Dynamic Containment Terms and Conditions

Amendment of EBGL Article 18 mapping to include Dynamic Containment Terms and Conditions requirements

EBGL Article 18 Dynamic Containment Terms and Conditions Consultation Responses summary

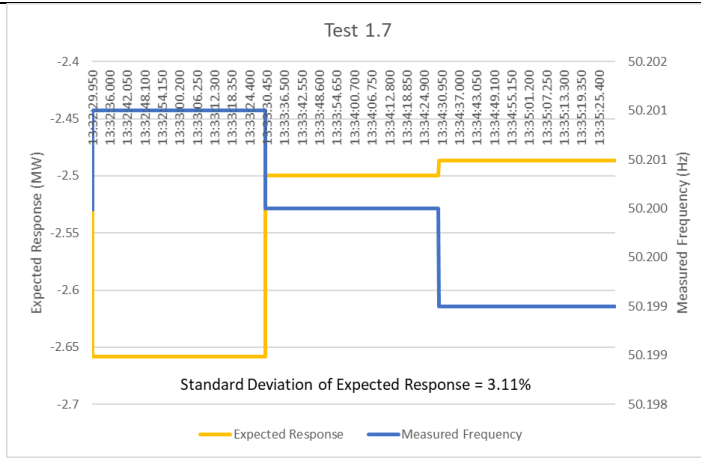
It is our view that the standard deviation pass/fail criteria in the DC Testing Guidelines Consultation Draft should be changed to be brought into line with the proposed changes made to the Allowable Power Tolerance.

Under the standard deviation pass fail criteria in the DC Testing Guidelines consultation draft the Allowable Power Tolerance for Test 1 has been relaxed to +-3% of maximum contracted power, however the pass criteria for standard deviation remains +-2.5% of expected active power response, which for certain tests can be challenging.

This is most apparent in tests 1.7 and 1.8, as these are at the knee point of the Dynamic Containment droop curve a small deviation in frequency measurement has a large effect on power. For example, for a 50MW plant, in test 1.7, the expected active power response is 2.5MW (5% of 50MW), and therefore the allowed standard deviation is 2.5% of 2.5MW, or 0.0625MW (62.5kW), which is equivalent to 0.13% of the maximum contracted power.

Additionally, the tightness of this standard deviation is such that in tests 1.7 and 1.8, the metering accuracy of the site alone can give results outside of the of the 2.5% tolerance, even with a meter that meets the DC Service Terms. For example, if a battery had no error in response or delay (which is of course impossible), then if the measuring error in the metering of the battery was 0.001Hz (as allowed under paragraph 15.5 of the DC Service Terms) and during the 3 minute test the measured frequency was at 50.201Hz for 1 minute, 50.2Hz for 1 minute and 50.199Hz for 1 minute, then the standard deviation of this test would be 3.11% and would fail the testing.

To address this, we suggest that the pass criteria for standard deviation is changed to +-2.5% of maximum contracted power, in line with the change to Allowable Power Tolerance.

time period of three minutes. We have now removed this from Test 1. We believe that now the assessment is more closely aligned with performance monitoring, tolerance bands will be used instead of Standard Deviation.
